COMMUNITY DESIGN INPUT WORKSHOP FOR THE BROOKLYN FACILITY

January 23, 2024

Brooklyn Borough Based Jail

BBJBK DESIGN WORKSHOP #2 COMMUNITY COMMENTS

WHAT WE HEARD - ARCHITECTURE

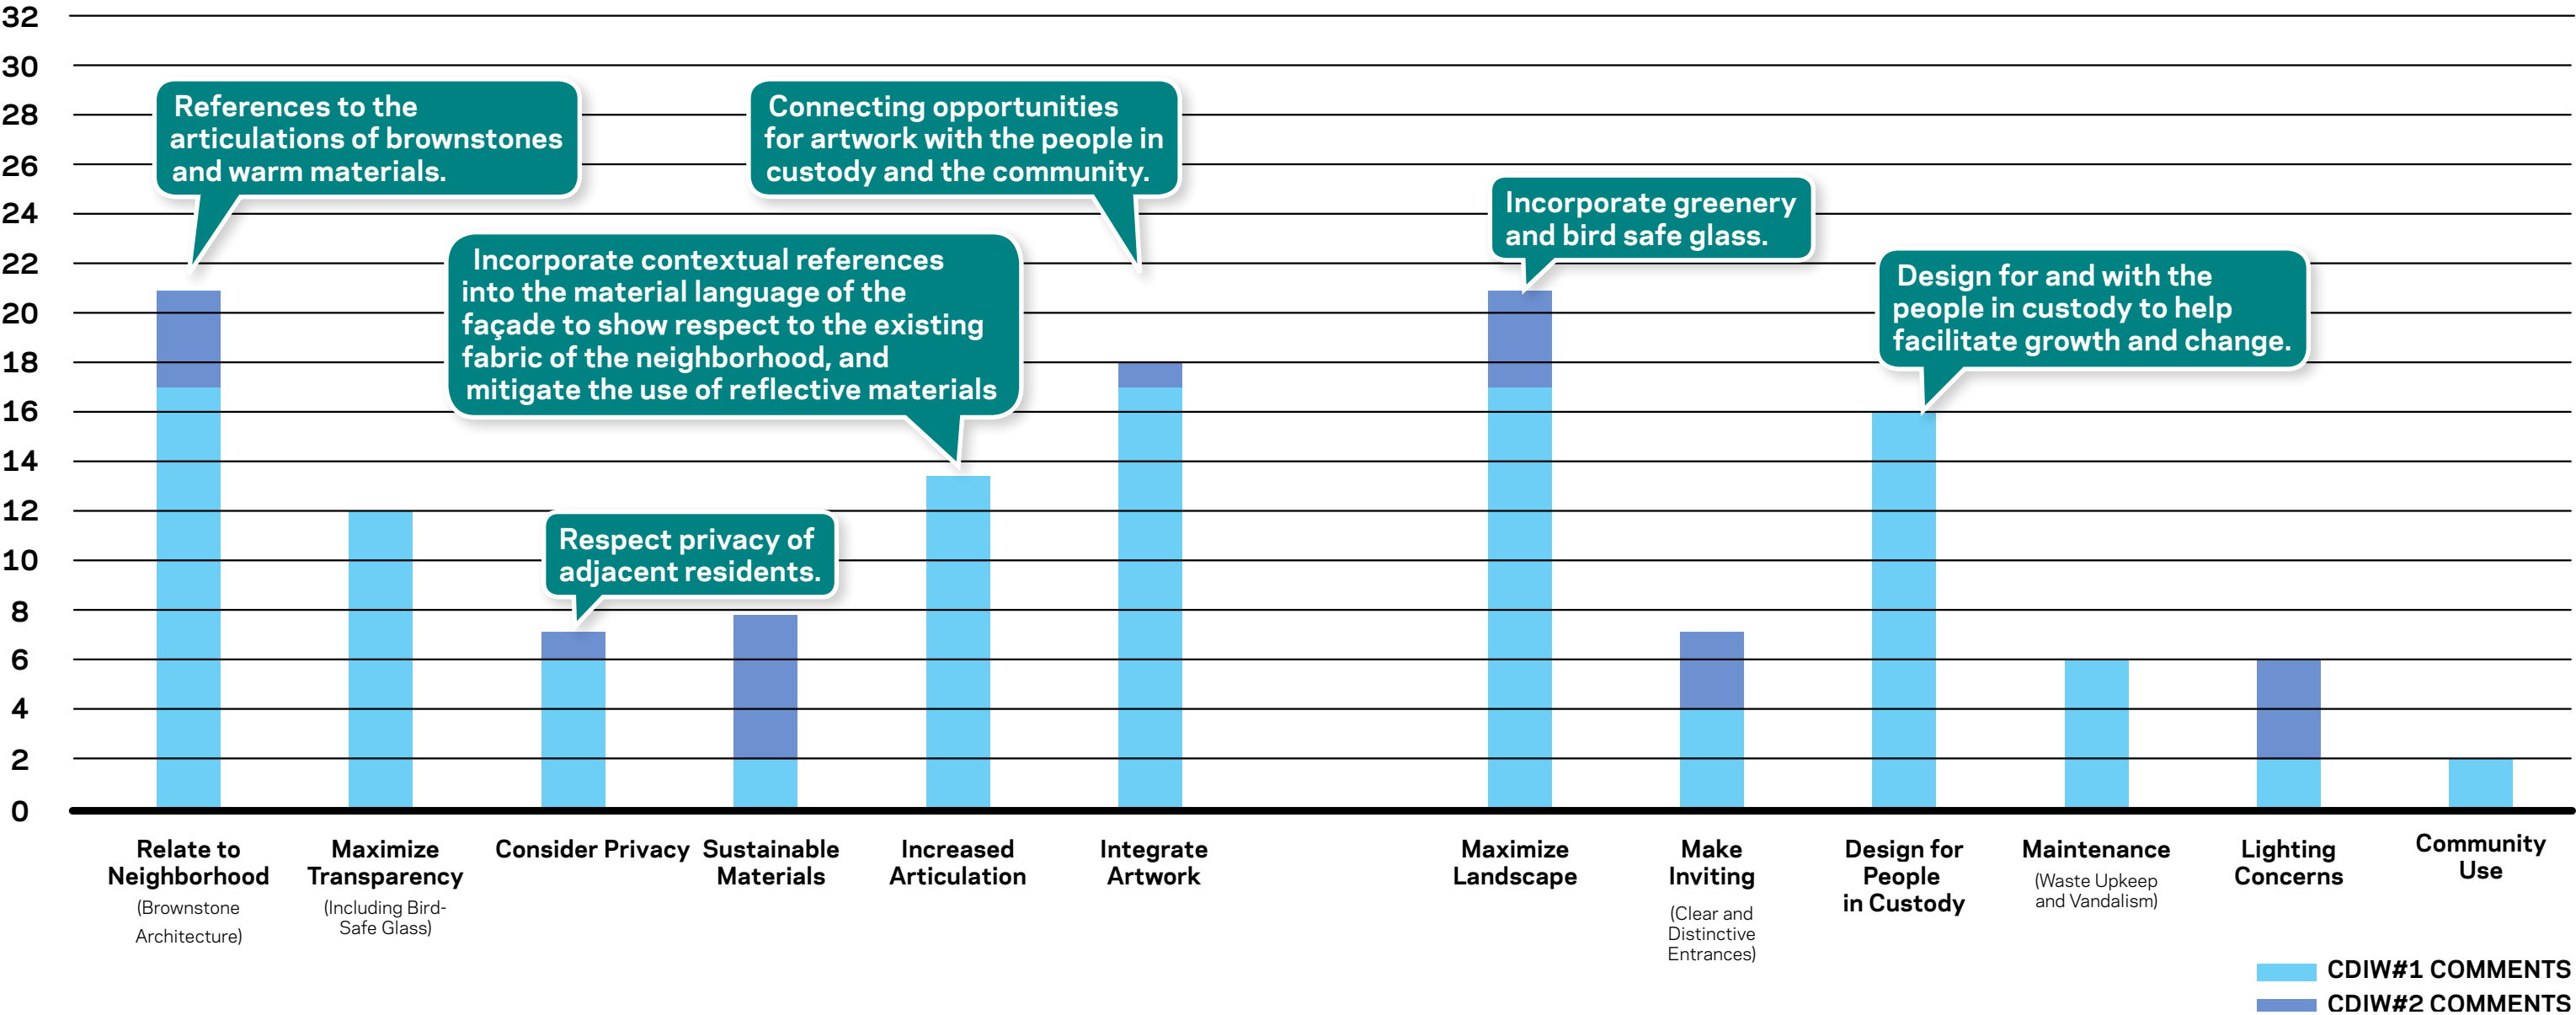
COMMENT	RESPONSE
ARCHITECTURE	
Sustainable Materials?	The Facility will seek LEED Gold certification for sustainability. Materials for the building are evaluated through the certification and the design will comply to the requirements.
Which side will residents come in on?	Visitors will enter the Facility through the main entrance located off the plaza on the corner of Boerum Place and Atlantic Avenue. This entrance will lead to a public lobby for the visitors. People in custody will enter the Facility through a secure entrance which is separate from the public lobby or staff entrances.
Light from within the Facility causes light pollution for adjacent neighbors, especially during events when internal lights are flashed.	The design team is studying the window design and treatments to consider visual privacy and impact on the surrounding neighborhood. Lights in the dayrooms will not be on 24/7, and lower light levels will be used in the housing units at night. In non-custody areas, motion-sensor lighting will be used so that lights are off when rooms are not in use.

The building massing corners on both ends of Atlantic Avenue should be open, especially the corner of Smith Street and Atlantic Avenue. Can the building massing be revised to accommodate a small plaza on the east?	Plaza space has been provided along Atlantic Avenue and Smith Street close to the east end of the building.
Bird mitigation for ledges?	The ledges are designed to discourage birds from perching by adjusting the angle of any protruding horizontal component.
Overshadowing? (53 Boerum Resident) ULURP (Uniform Land Use Review Process)	Shadow studies were undertaken during the ULURP process which determined the maximum envelope permitted for the Facility. The proposed design is smaller than the maximum permitted envelope.
Can more translucent material be used to allow light through? (53 Boerum Resident)	The building includes areas with both translucent and clear glass, depending on the use behind it, to maximize the amount of natural light in the Facility.

What is the name and logo of the facility?	The name and logo for the new facility will be determined at a future date.
Where do visitors come in?	Visitors will enter the Facility through the main entrance located off the plaza on the corner of Boerum Place and Atlantic Avenue. This entrance will lead to a public lobby for the visitors.
Public Art?	This project is participating in the New York City Percent for Art Program.
Canopy feels intimidating because sharp, large, size, Color = how to better reflect brownstones? Maybe needs more detail to soften. Brownstones usually set back 15ft = this building feels more imposing. More detailing at human scale/close to ground where people actually walk and interact. See their surrounding -- do more views to illustrate eye level experience	We have refined the design of the canopy, especially to include wood look material and integrated lighting to make the space welcoming. Additionally, we have modified the profile of the canopy. The proposed Facility massing is smaller than the maximum permitted ULURP envelope. Furthermore, the building includes additional setbacks that break down the scale. We have included additional street level views to illustrate street level experience.

Color Scheme?	The materials and colors selection process is in preliminary stage. The warm colors of panels continue to reinforce connection to surrounding context.
Construction Frame shorter because Reduced parking? When does construction begin?	The construction schedule and budget factors in the reduced parking. We anticipate Brooklyn's construction to begin in the second half of 2024 and to complete in 2029.
Demolition has already taken a long time	Dismantle is anticipated to be complete in Spring 2024.
Sustainable Energy?	The Facility will seek LEED Gold certification for sustainability.
Annual Cost saving?	This is being assessed by the City.
Solar Panels?	Photovoltaic panels will be installed within the Facility.
Are facility and community entrances separate?	Visitors will enter the Facility through the main entrance located off the plaza on the corner of Boerum Place and Atlantic Avenue. This entrance will lead to a public lobby for the visitors. People in custody will enter the Facility through a secure entrance which is separate from the public lobby or staff entrances.

COMMENT	RESPONSE
We might not want to hang out in the area near the lobby. Why not create some public space near Smith Street?	The design includes streetscape improvements on all sides of the building including integrated seating to allow for social gathering of different types.
Very nice use of different materials.	Thank you.
What kind of community uses? Permanent use?	There is 30,000 s.f. of dedicated community space that is currently undefined. The use of the community space will be determined at a later time with input from the community.
It is important that this building fit into a neighborhood which is historic, well maintained and full of life. It should not overwhelm, darken, be too massive. It should not feel institutional. Its architecture should be something that tastefully goes into the future. Can the vertical elements and the "shelves" be maintained well and is this a lasting style. I was happy that this building would be LEED gold. I would love to see it have surface plantings. This can be very beautiful and humanizing.	The proposed Facility massing is smaller than the maximum permitted ULURP envelope. Furthermore, the building includes additional setbacks that break down the scale. The design of the exterior has been carefully considered to be sympathetic to the surroundings and to become a civic asset. It interprets the language of the surrounding civic buildings. The materiality chosen directly relates to these surrounding buildings as well.

Consider the light coming from the jail windows. There is a facility on Atlantic Ave which has glaring bright light coming all night, sometimes flashing. This amount of light cannot be healthy for residents of the space and is certainly a negative for the people living within its reach. We live on State Street but have this light flooding into our bedrooms all night. When I asked about the light and how it would affect the neighboring residents, I was told it would be looked into as if had not yet been a consideration.	The design team is studying the window design and treatments to consider visual privacy and impact on the surrounding neighborhood. Lights in the dayrooms will not be on 24/7, lower light levels will be used in the housing units at night. In non-custody areas, motion-sensor lighting will be used so that lights are off when rooms are not in use.

WHAT WE HEARD - INTERIOR PUBLIC SPACE

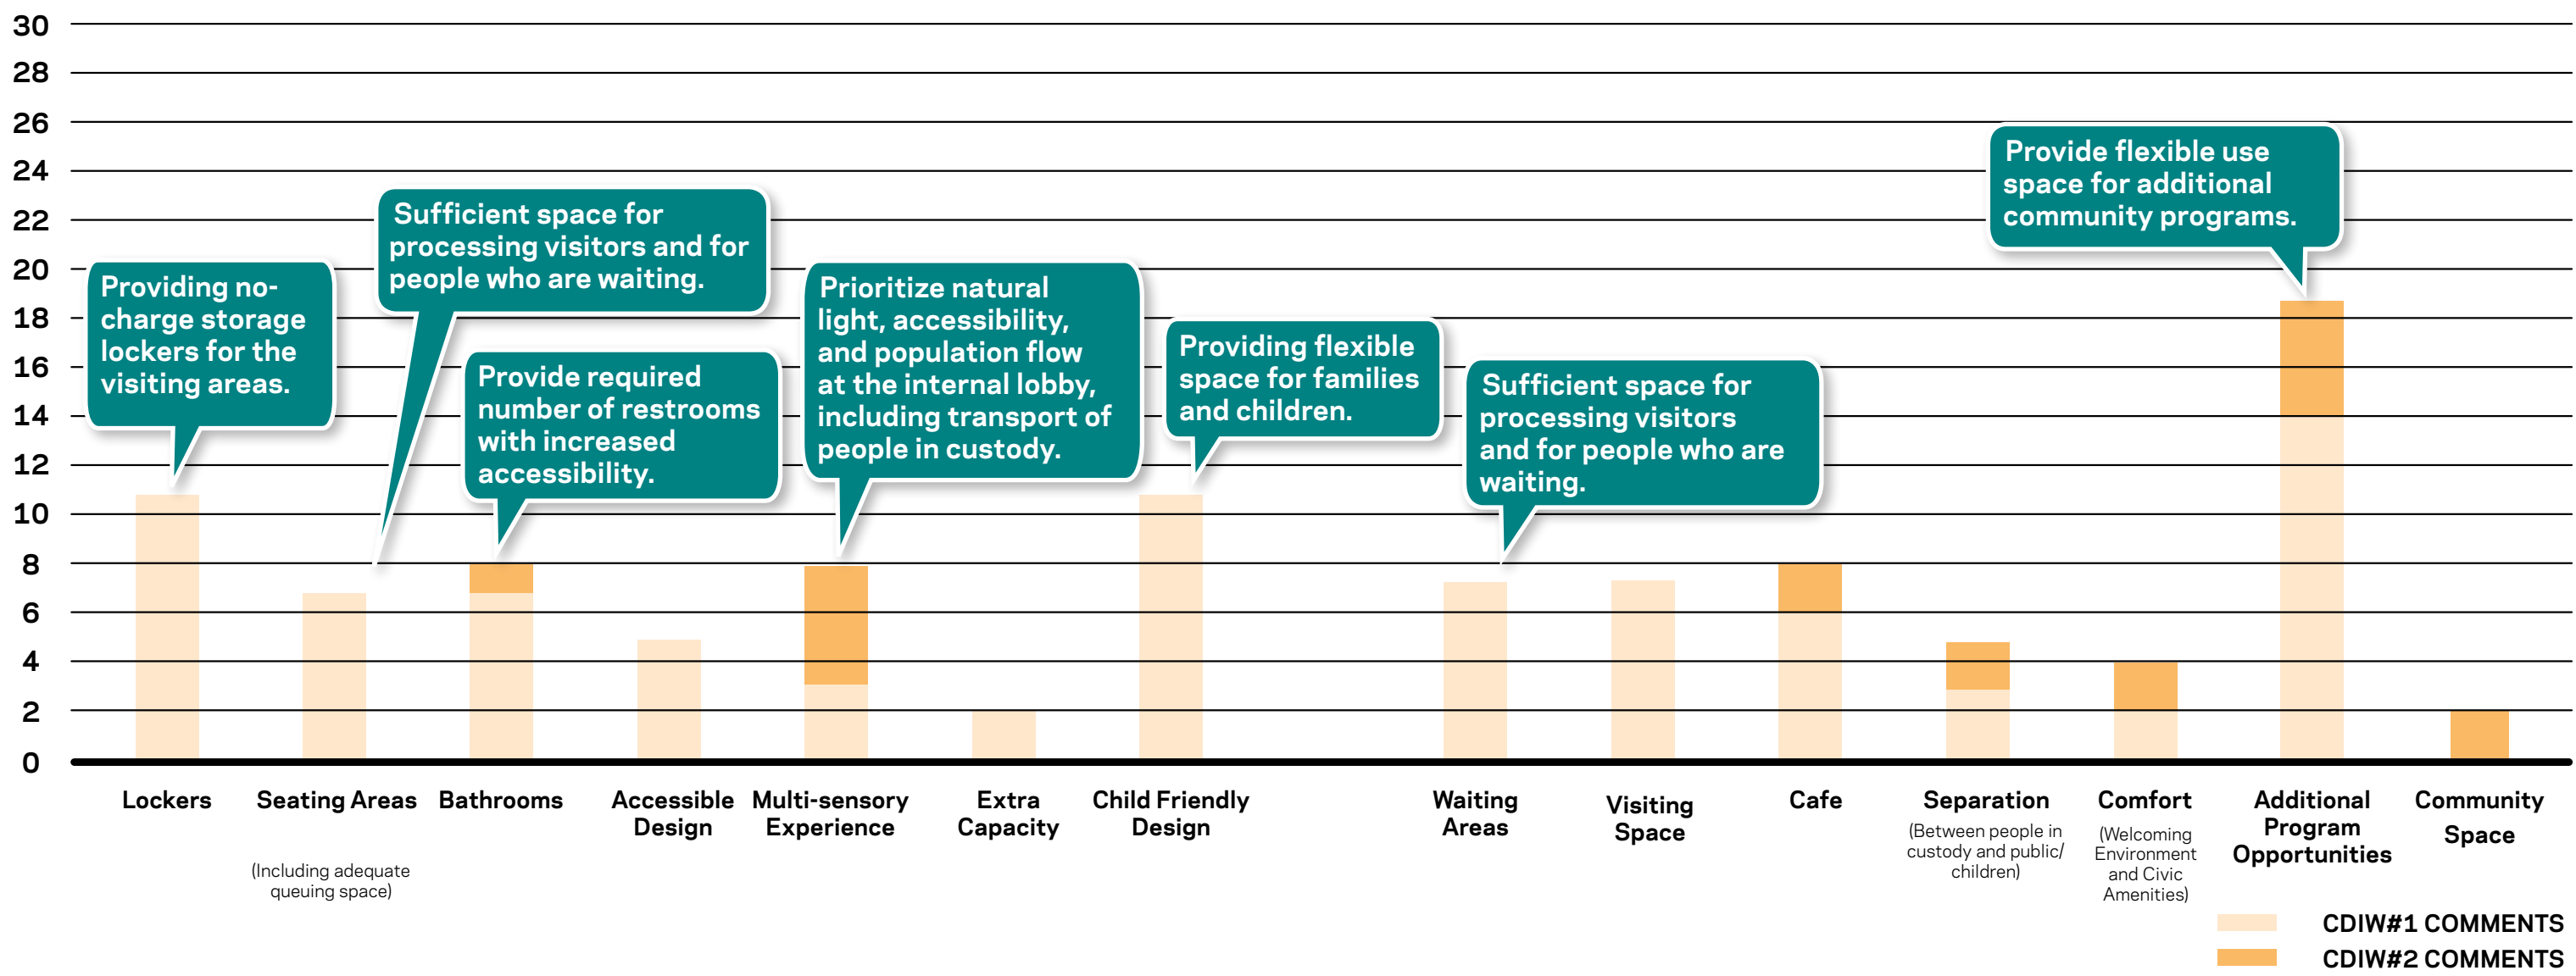
COMMENT	RESPONSE
INTERIOR PUBLIC SPACE	
Welcoming entrance for staff and visitors	A generous indoor lobby is being designed to be calming and include warm materials to create a positive human experience.
How is prioritization of who has access to community space determined? Will it be for justice-impacted folks?	There is 30,000 s.f. of dedicated community space that is currently undefined. The use of the community space will be determined at a later time with input from the community.
Will there be a designated area that separates children in different age groups? For example, keeping the teens separate from younger children.	Each person in custody will have their own cell, which includes a separate sink and toilet.
Will there be specialized programs available for early childhood/older kids and getting neighborhood schools involved?	The facility will include 30,000 s.f. of dedicated community space that is currently undefined. The use of the community space will be determined at a later time with input from the community.

Why are we not seeing any renderings of what the indoor spaces are going to look like?	View of interior spaces will be included in Workshop #3.
What will be the living conditions for the people in custody?	Each person in custody will have their own cell and access to dayrooms and outdoor areas. Additionally, they will have direct access to programs in their housing unit. In addition, the Facility will include a wide variety of programming, including horticulture program, culinary arts program, vocational training, library, gymnasium, chapel, and medical facilities.
Will they have windows?	Windows will be provided in every cell and all dayrooms and recreation areas will have natural light.
Will people in custody be able to look outside from their cells?	Yes, each cell will have exterior views
IMPRESSIVE PRESENTATION	Thank you
How will the community space be maintained?	The facility will include 30,000 s.f. of dedicated community space that is currently undefined. The use and maintenance of the community space will be determined at a later time with input from the community.

Will there be toilets in the cells?	Yes, there will be a toilet in each cell.
Concerns regarding people in custody passing each other contraband in outdoor areas.	All outdoor areas will be supervised by staff
There are mesh security concerns, like the appearance of the mesh (color, thickness).	An architectural mesh with a warm color is proposed on the outside of the recreation areas to mitigate any security look.
Who can access the community space?	The facility will include 30,000 s.f. of dedicated community space that is currently undefined. The use of the community space will be determined at a later time with input from the community.
Are there different options for people with neuro diversity, such as spaces with sensory reduction?	The Facility will have internal spaces with neurodiversity in mind. This includes providing different seating options, lighting strategies that create a calming glow, purposely placed artwork for moments of distraction/respite, varying textures, and warming earth tones as an overall base material palate.

How will different organizations be able to utilize the public space?	The facility will include 30,000 s.f. of dedicated community space that is currently undefined. The use of the community space will be determined at a later time with input from the community.
Will people in custody have access to see residents from the next building, or anything across the street?	The design team is studying the window design and treatments to consider visual privacy and impact on the surrounding neighborhood.
Who will maintain the vending machines if they break? Because sometimes when you're visiting people in custody and you want to buy something from the vending machine, most of the time they don't work.	DOC contracts with a 3rd party to provide vending machine services and that party is responsible for maintaining the machines.
Will there be a cafeteria, or a coffee machine in the public lobby?	Vending machines will be provided

COMMENT	RESPONSE
How will people with visual impairment be able to navigate through the space?	The building is designed to be fully ADA compliant. This includes cane detection, no obtruding objects, clear circulation, braille, and natural wayfinding strategies.
Is there pet therapy for people who have visual impairment?	Space has been allocated in the facility for a pet therapy program to be implemented and will be available for individuals in custody.
Getting neighborhood schools involved, will there be programs available?	The facility will include 30,000 s.f. of dedicated community space that is currently undefined. The use of the community space will be determined at a later time with input from the community.
Indoor images/rendering concerns: want to see!	Renderings will be availble for next workshop
Will there be specialized spaces for programs for early childhood and older kids.	The facility will include 30,000 s.f. of dedicated community space that is currently undefined. The use of the community space will be determined at a later time with input from the community.

What are the living conditions for people in custody? Window size for outside views. Will people in custody have accessibility to look outside?	Window size is being studied and all cells will have views to the outdoors
Connection between lobby and community space and sidewalk	There will be no connections from the main lobby to the community space
Will there be different categories for young children vs for teens because you don't want pre-k kids in the same space as teens.	Separate spaces are included for children and teens both in the lobby and visiting areas. There will be areas catered towards younger children and more charging areas for teens to bring their own devices.
Impressed.	Thank you
How will community spaces be maintained?	The facility will include 30,000 s.f. of dedicated community space that is currently undefined. The use of the community space will be determined at a later time with input from the community.

Toilets in each cell? (No)	Yes, there will be a toilet in each cell.
Outdoor recreation activities? Mesh concerns (security). Softening appearance of mesh.	An architectural mesh with a warm color is proposed on the outside of the recreation areas to mitigate any security look.
Who can access the community space?	The facility will include 30,000 s.f. of dedicated community space that is currently undefined. The use of the community space will be determined at a later time with input from the community.
Are there different options for people with neuro diversity, such as spaces with sensory reduction?	The Facility will have internal spaces with neurodiversity in mind. This includes providing different seating options, lighting strategies that create a calming glow, purposely placed artwork for moments of distraction/respite, varying textures, and warming earth tones as an overall base material palate.

How will different organizations be able to utilize the public space?	The facility will include 30,000 s.f. of dedicated community space that is currently undefined. The use of the community space will be determined at a later time with input from the community.
Who will maintain vending machines if they break?	DOC contracts with a 3rd party to provide vending machine services and that party is responsible for maintaining the machines.
Pet therapy for people who have visual impairment?	Space has been allocated in the facility for a pet therapy program to be implemented and will be available for individuals in custody.
